REQUEST

Current Zoning: R-3 (single family residential)
Proposed Zoning: R-8(CD) (single family residential, conditional)

Approximately 4.98 acres located on the south side of Sam Neely Road, west of Steele Creek Road, and east of Krislyn Woods Place.

SUMMARY OF PETITION

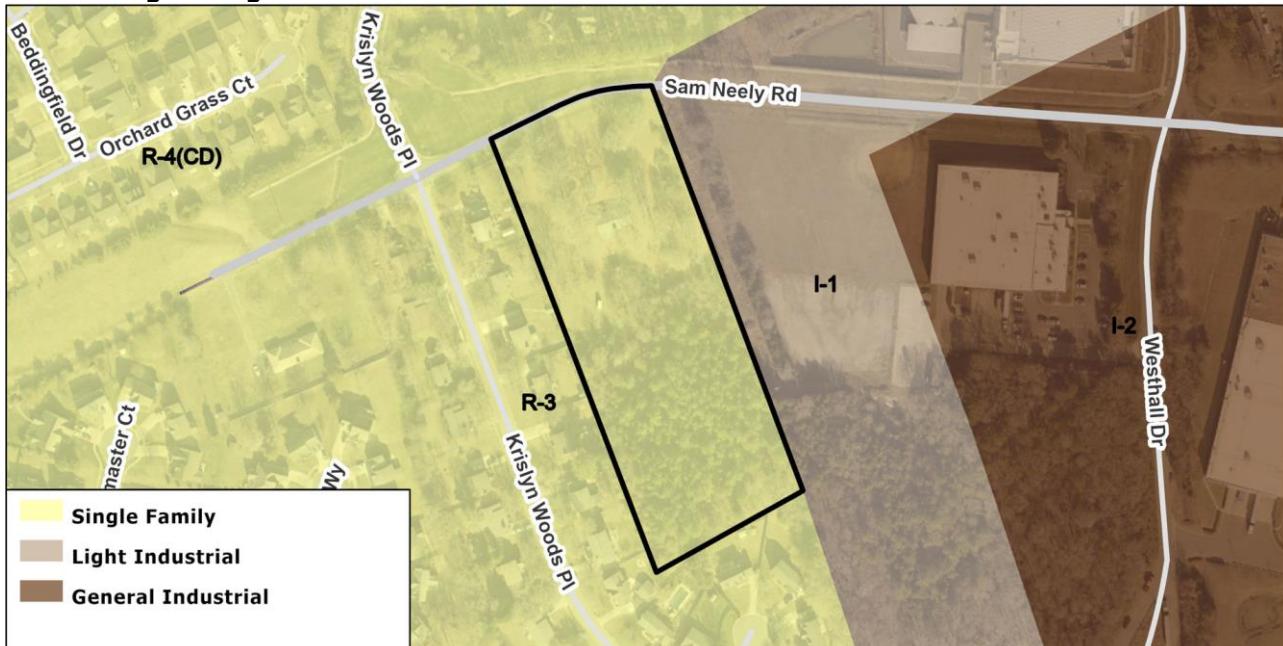
1. Adjust buffers for the site's eastern boundary to reflect a 35' Class A Buffer which can only be reduced by 25% with a berm.

2. Adjust tree save areas shown on the site plan to ensure compliance with the Tree Ordinance.

3. Adjust total number of committed parking spaces from 53 to 54 to accurately reflect the commitments of 2 spaces per unit and 6 visitor spaces.

4. Add open space details in note I. which are committed to on the site plan and in the Development Data Table.

5. Show and label the visitor spaces on the site plan.
